# Request for Continued Examination (RCE) Transmittal

Application Number	10/798,693
Filing Date	03/11/2004
First Named Inventor	Stanton
Art Unit	3673
Examiner Name	LEE
Attorney Docket Number	CLPS-18789

**RESPONSE TO OFFICE ACTION DATED JUNE 10, 2009**

FIG. 6

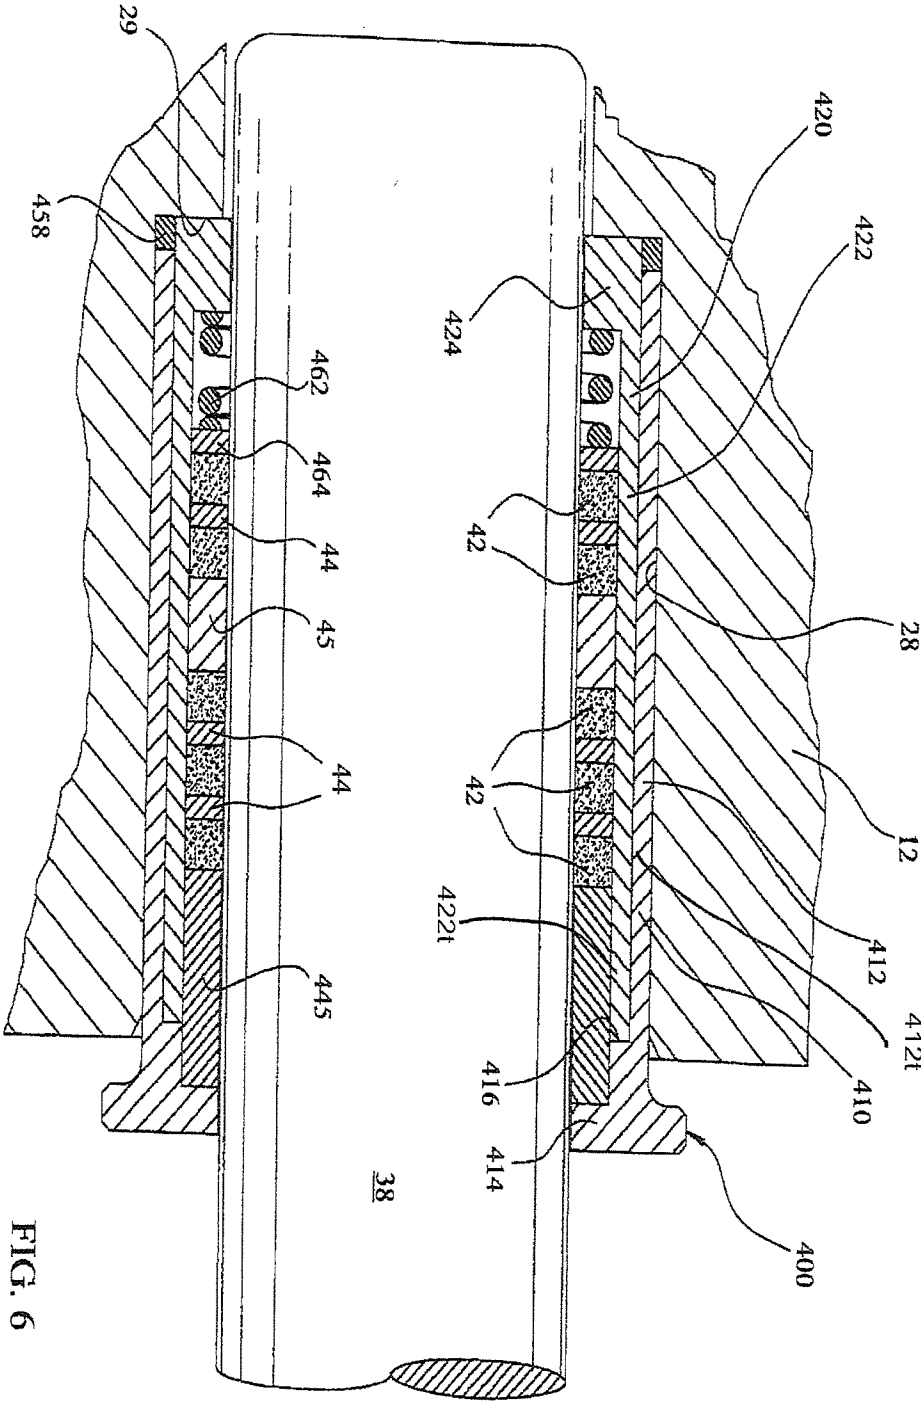
The drawings were objected to under 37 CFR 1.83(a) because the specific terms “telescoping structures” as used in the currently- pending claims were not identified in the drawings. Applicants amend as required by the Examiner.

Regarding Figures 6 and 12, Paragraphs 0156 and 0158 of the specification are amended to include the specific references 412t and 422t for the “telescoping structures” and Figures 6 and 12 of the drawing is amended to include these references. Figure 12 is a cross-sectional view of another embodiment of a packing cartridge similar to the embodiment shown in Figure 7 (*See, e.g.*, Specification Paragraphs 0076 and 0193), where Figure 7 is a cross-sectional view of another embodiment of a packing cartridge similar to the embodiment shown in Figure 6 (*See, e.g.*, Specification Paragraphs 0068 and

[0156] Preferably, a spacer ring **445** is positioned operatively to cover the overlapping travel of the telescoping structures 422t and 412t between the first and second sleeve portions **410** and **420**. This spacer ring **445** helps prevent seepage of fluid into any clearances between the first sleeve portion **410** and the second sleeve portion **420**. The spacer ring **445** can also act as a back-up ring for the packing rings **42**.

[0158] As will be appreciated, the telescoping structures 422t and 412t of the first sleeve portion **412** and the second sleeve portion **422** allow for squeezing of the first abutment ring **414** and the second abutment ring **424** co-axially closer to one another after positioning the pre-assembled packing cartridge **400** on a plunger **38** in the packing bore **28**. However, in this embodiment, the packing cartridge **400** is positioned in the packing bore **28** and tightened by a gland nut (not shown) until the second sleeve portion **422** bottoms out against a shoulder **416** of the first sleeve portion **412**. In this position, the coil spring **462** is compressed with a packing assembly positioned between the first abutment ring **414** and a second abutment ring **424**. The advantage of bottoming out the telescoping structures 422t and 412t is that it prevents over-tightening of the packing cartridge **400** in the packing bore **28**. The spring **462** maintains a pre-determined amount of axial compression on the packing rings **42** of the packing stack.
